ADDENDUM NO. 1
MAY 28, 2025

EAST CHINA TOWNSHIP, MICHIGAN
DPW SERVICE BUILDING

**EAST CHINA TOWNSHIP, MICHIGAN
DPW SERVICE BUILDING
ANSWERS TO CONTRACTORS' QUESTIONS PRIOR TO BIDDING 5-28-25**

DESIGN BY: AG / RK	REV: 12-19-24 DATE: 10-10-08	1 OF 1	 KENNEDY SOLUTIONS, INC. 10051 Bergin Road Howell, MI 48843 Ph: 517-225-8338
MANUF. APPROVAL BY: .	SCALE: NTS	SHEET NO.	
DRAWING NO. SEPARATOR TANK VIEWS v25

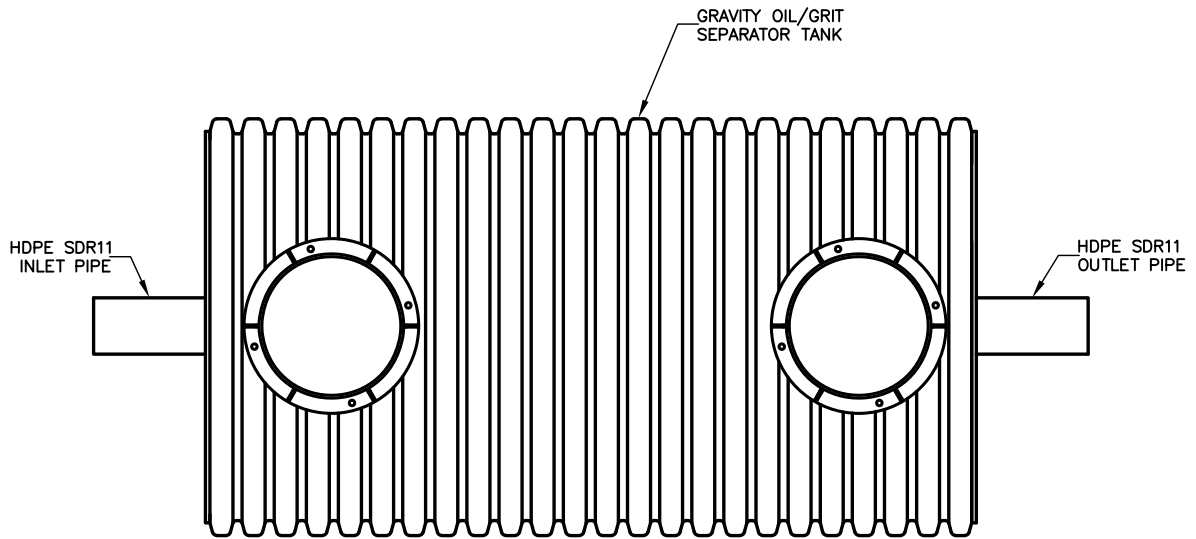
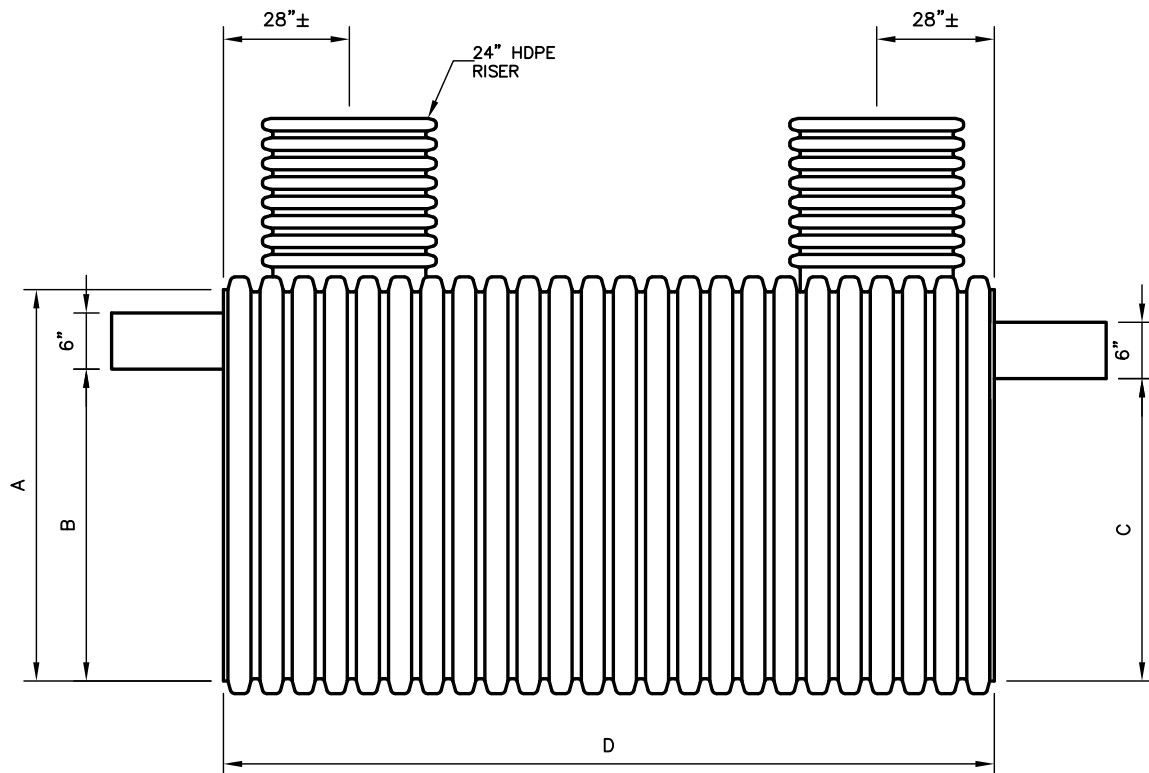
Question #1: Please clarify if an oil separator is required; if required, please provide a specification.

ANSWER: AN OIL INTERCEPTOR IS REQUIRED. DRAWING SHEET C-2 IS REISSUED TO SHOW THE PROPOSED 1500 GALLON OIL INTERCEPTOR, INSTALLED OUTSIDE OF THE BUILDING. OIL INTERCEPTOR SPECIFICATION SHEETS (10 PAGES) HAVE ALSO BEEN ATTACHED.

SLIDING GATE DETAIL
NO SCALE

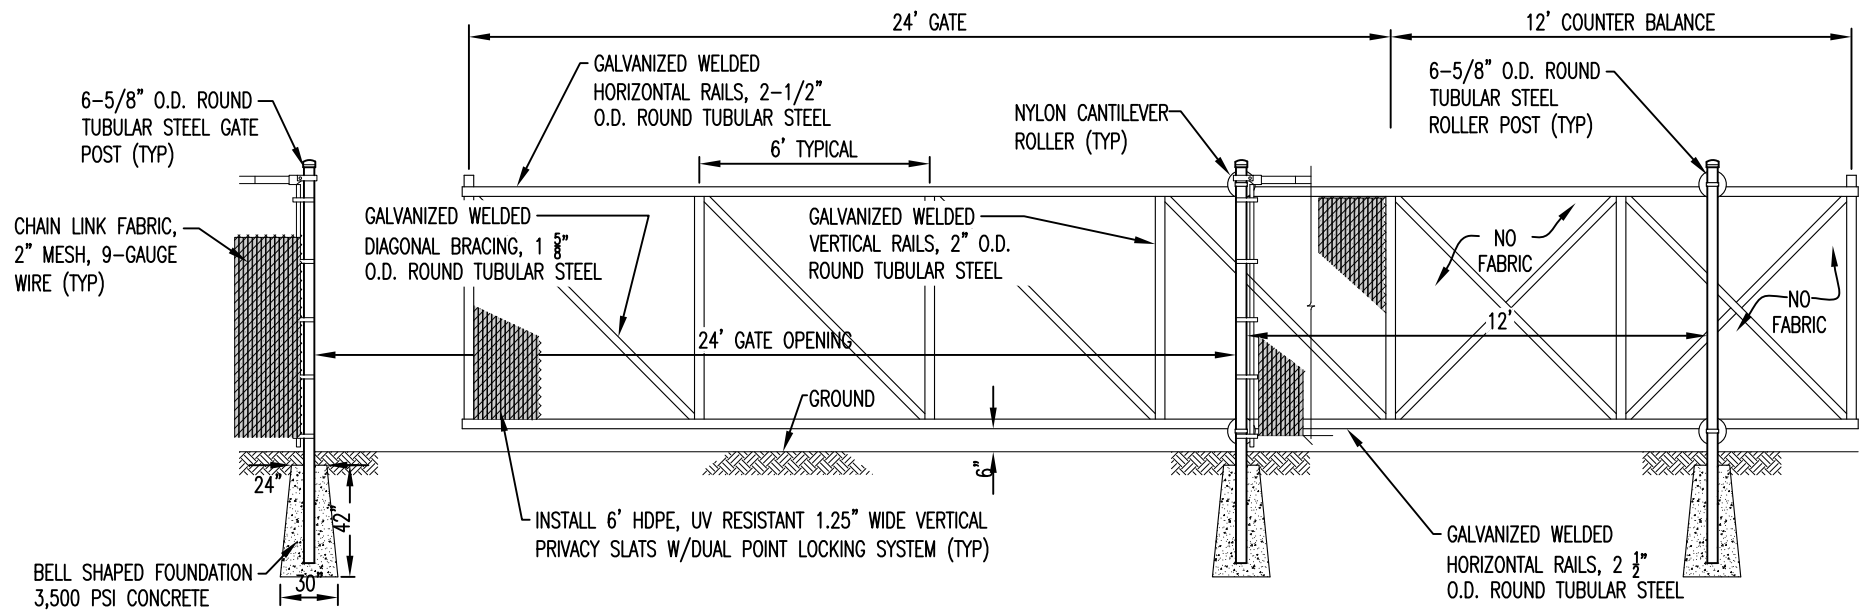
Question #8: Please provide a specification for the Chain Link Fencing.

ANSWER: SEE ATTACHED DETAILS FOR THE SWING GATE & SLIDING GATE

SITE PLAN

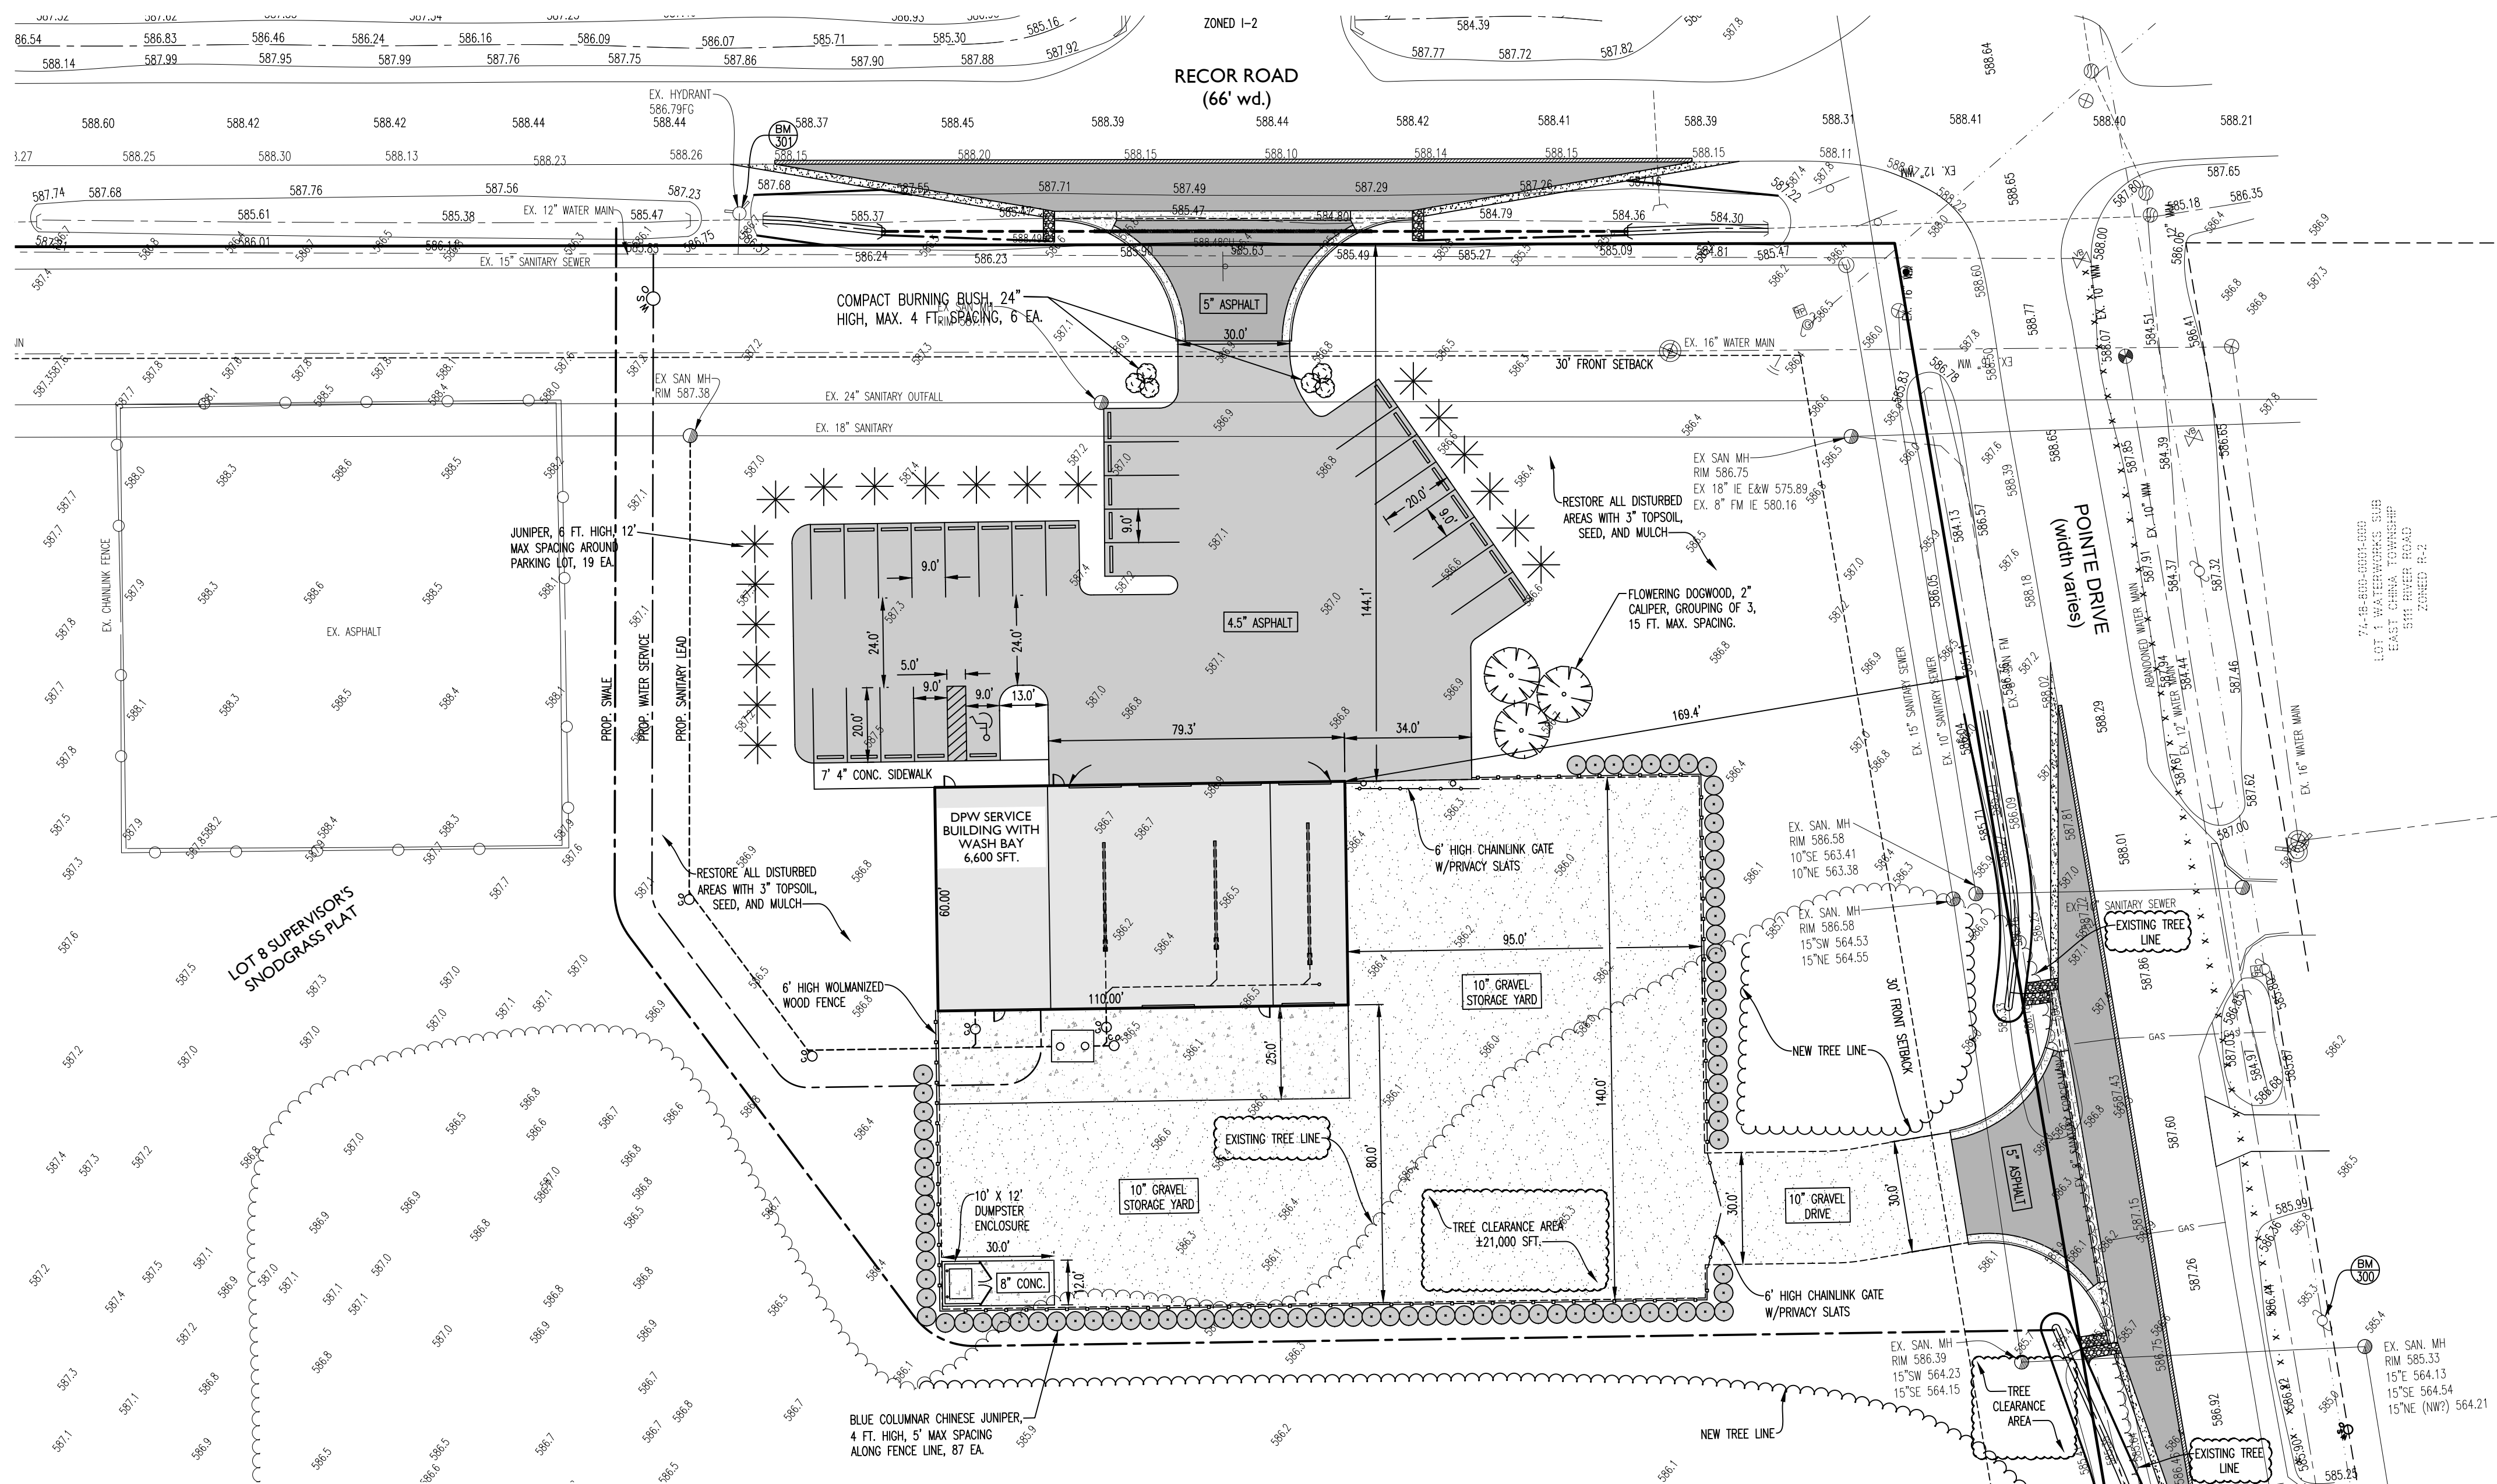
Question #18: Can a topographic survey of existing conditions be provided, so the area of tree removal can be calculated.

ANSWER: THE SITE PLAN SHEET # C-1 HAS BEEN REISSUED WITH THE EXISTING TREE OUTLINE AND REMOVAL AREA CALCULATION

DATE: 5-22-2023
REVISION DATE:
6-22-2023 per planning
8-2-2023 per PCE
10-2-2023 per planning
4-29-2024 per SCCRC REVIEW
5-12-2025 per Township
5-28-2025 ADDENDUM #1: TREE CLEARING
